February 12, 2025

**ADDENDUM NO. 4
TO THE
CONTRACT DOCUMENTS
FOR
CUMBERLAND COUNTY TRANSFER STATION**

PROJECT TITLE:
ANN STREET LANDFILL SOLID WASTE TRANSFER STATION TRANSFER STATION

DRAWING TITLE:
UTILITY PLAN

DESIGNED	PROJECT NO.
J.D.B.	CUMBERLAND 22-1
DRAWN	SCALE
J.R.T.	AS SHOWN
APPROVED	DATE
S.A.S.	DEC. 2024
FILENAME	
CUMBERLAND-D0263	
SHEET NUMBER	DRAWING NUMBER
7	S6

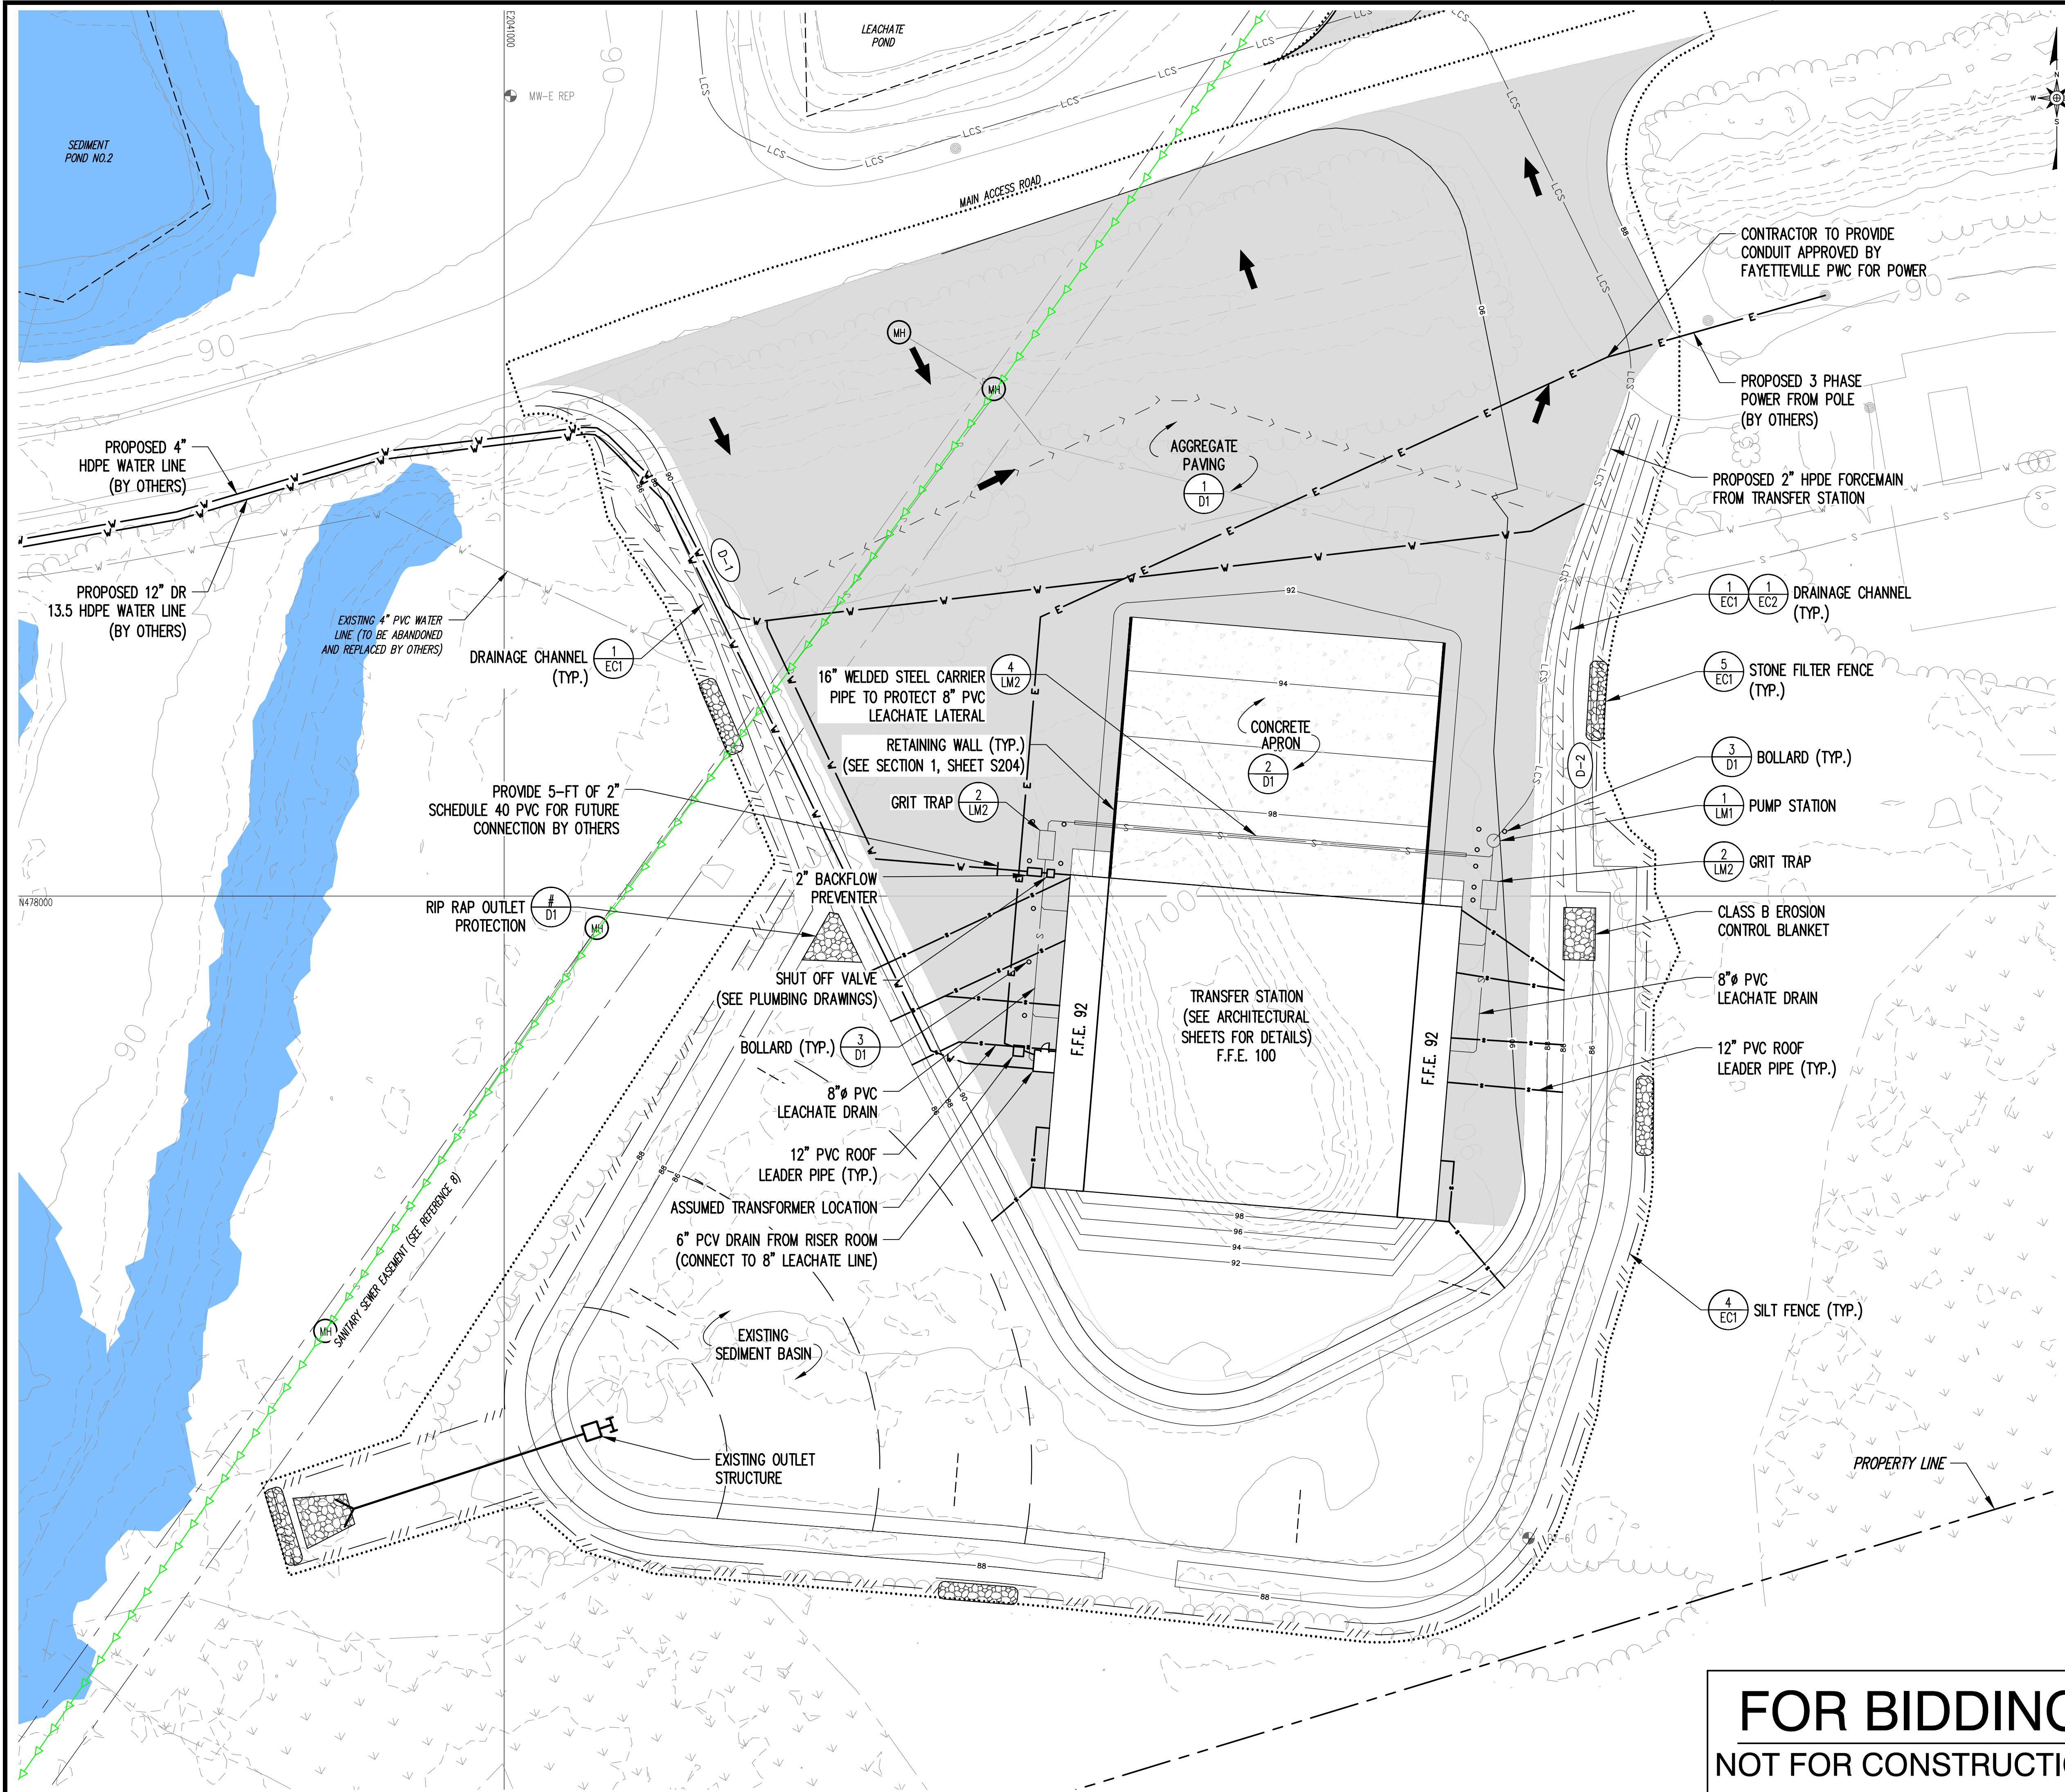
AD4-3. *Please clarify the location of the transformer. It is not shown on Sheet 7, Drawing S6.*

AD4-4. *Clarify the conduit size required by the note on Sheet 7, Drawing S6.*

See attached Bulletin Drawing.

Contractors shall stipulate the conduit size they will supply in their bid. In the event the conduit size is different than that stipulated based upon final location of PWC service, the change may be included in a Change Order.
